Appendix H

Comments Received and Responses

U.S. Forest Service Comments on Draft Submittal

Kentucky Draft Regional Haze State Implementation Plan (RH SIP) - Specific Comments

Figure 32: East Bend Station Unit 2 NO_x Emission Rate Trends (2012-2021)

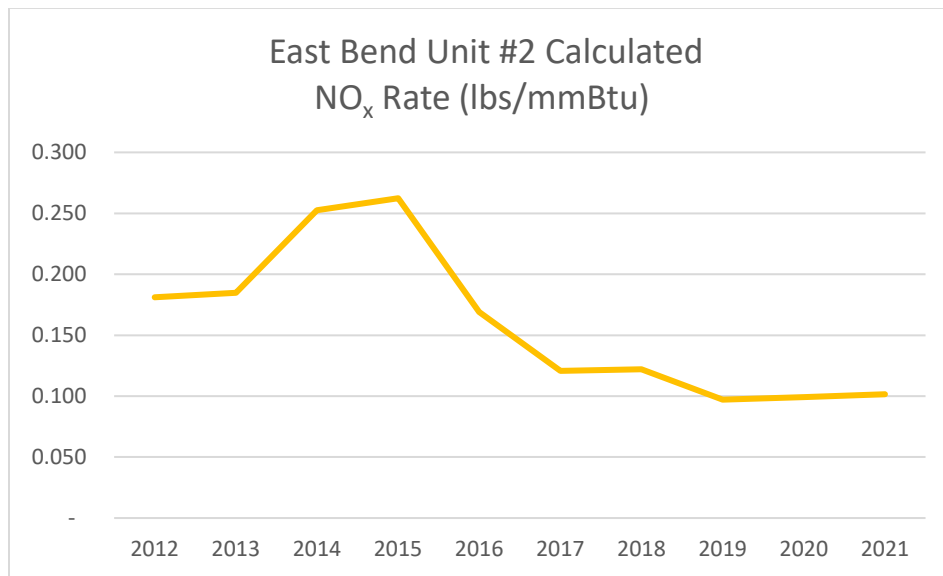
As shown in Figure 32 above, SCR performance on Unit 2 has been steadily improving or consistent in the last seven years. However, rates are still above the 0.08 lb/MMBtu recommended in EPA’s good neighbor proposal. The NPS recommends evaluating SCR optimization for Duke Energy East Bend Unit 2.

Figure 33: E.W. Brown Station Unit 3 SO₂ Emission Rate Trends in lb/MMBtu (1997-2021)

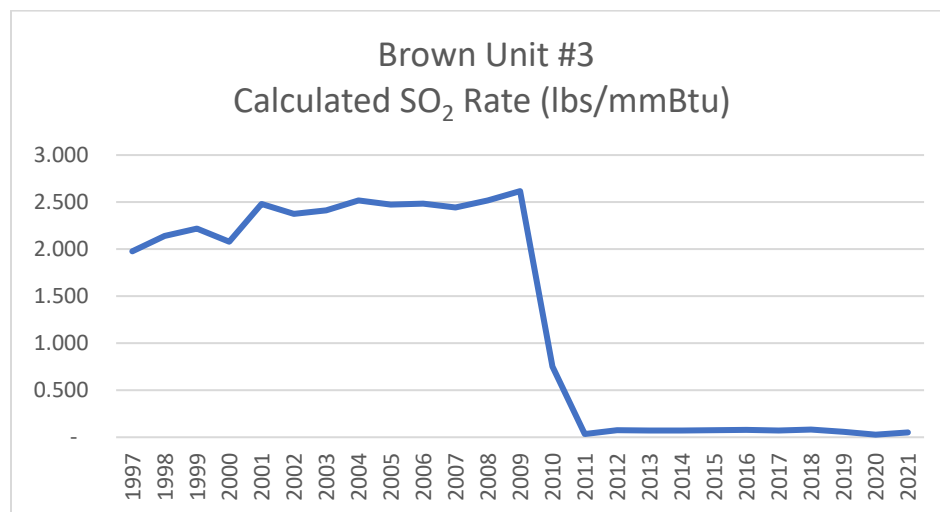
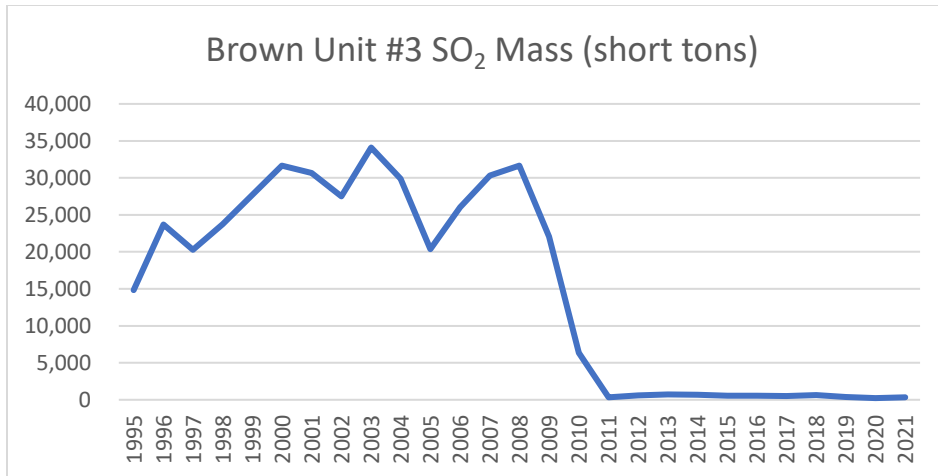
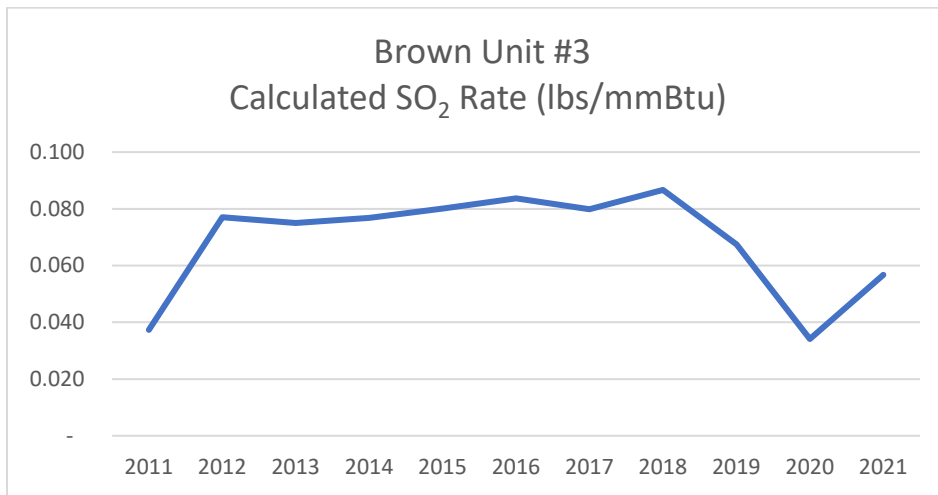
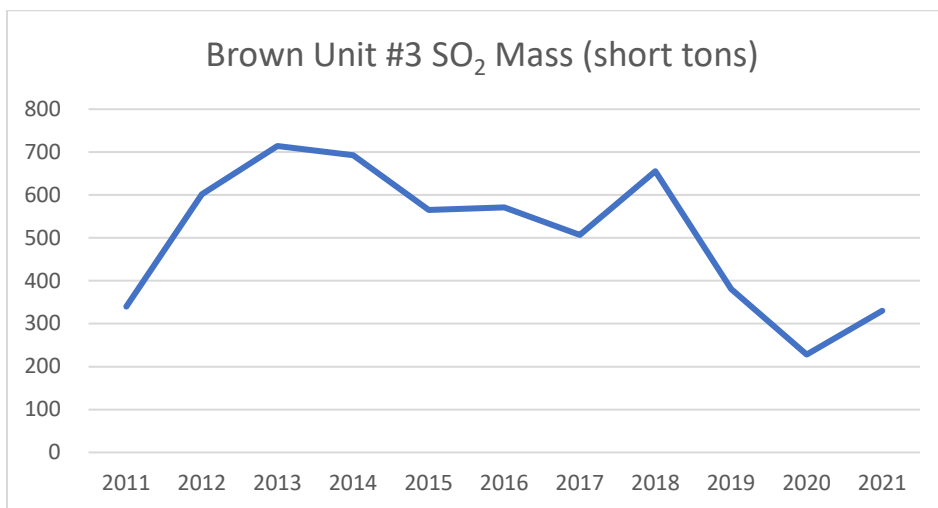
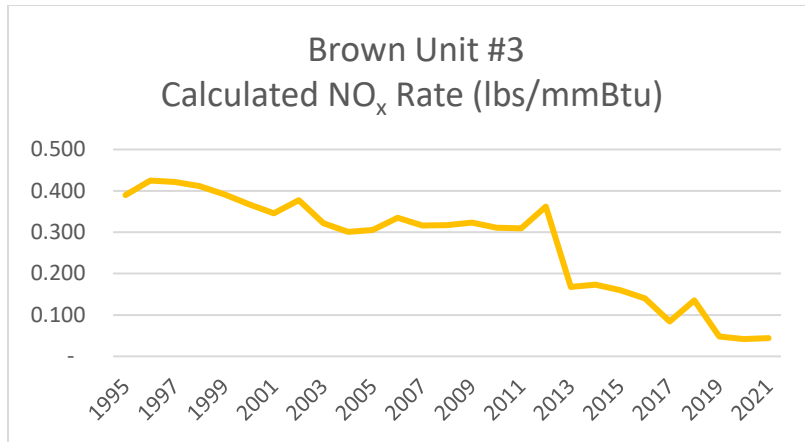
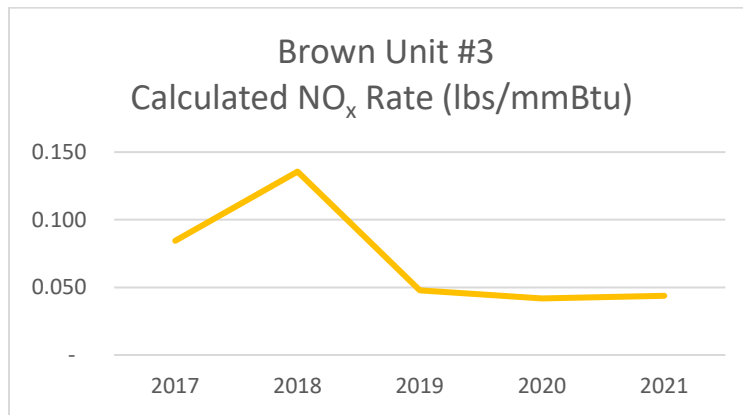
The following figures provide SO₂ and NO_x emission rate trends for Brown Station Unit 3. Current emissions are much lower than historic levels due to control equipment installations in 2010 and 2012. Furthermore, online resources indicate that Unit 3 is expected to retire by 2028.

If the facility continues operating beyond 2028, the NPS recommends requiring scrubber operation such that SO₂ emissions reflect 2020 emission rates. In addition, the SCR may require limits to ensure that controlled NO_x rates remain at 2019-2021 levels. This may be required under the “good neighbor” proposal.)

Figure 41: Cooper Station Unit 1 SO₂ Emission Rate Trends (2017-2021)

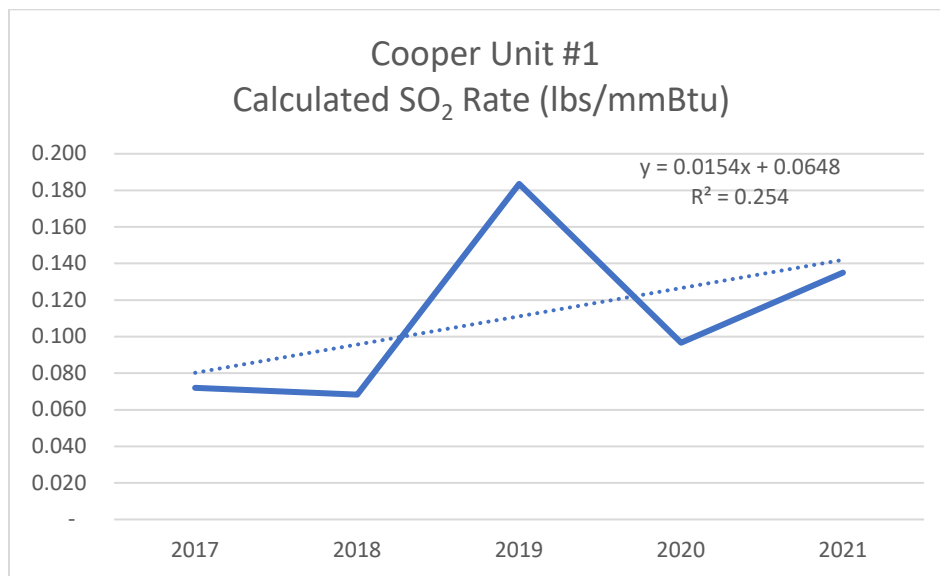
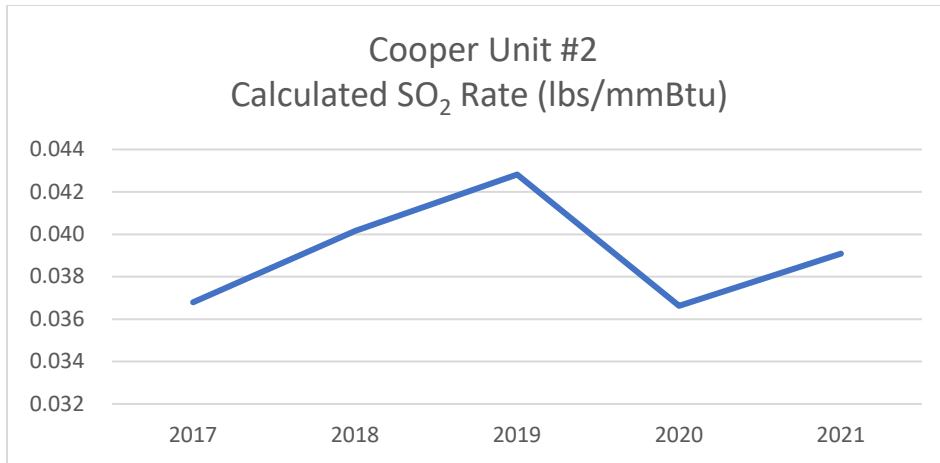
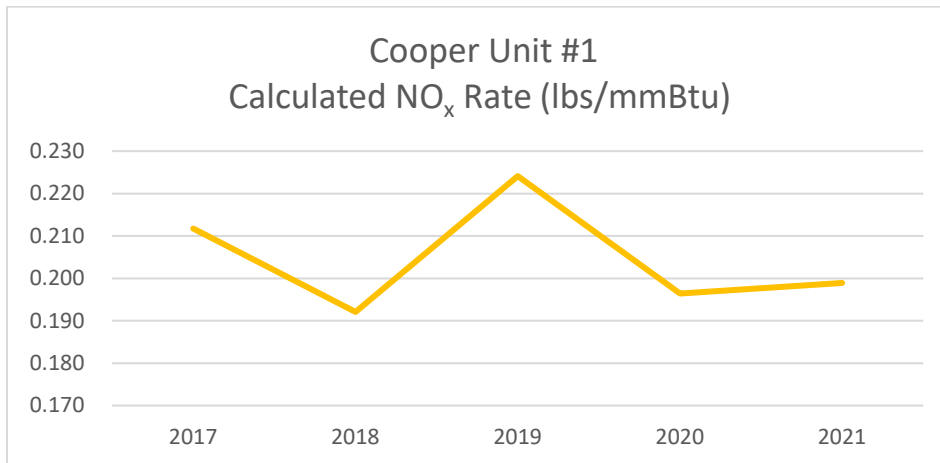
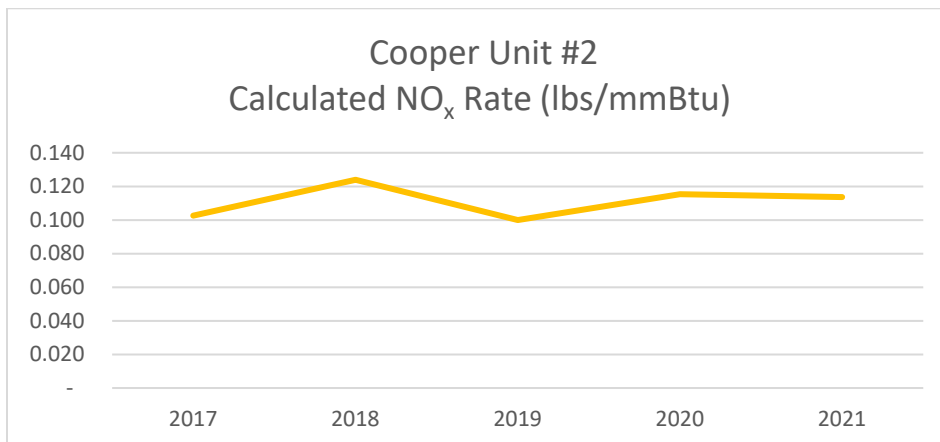
The following figures provide SO₂ and NO_x emission rate trends for Cooper Station Units 1 and 2. The NPS notes that current emissions are much lower than historic levels due to low utilization beginning in 2015.
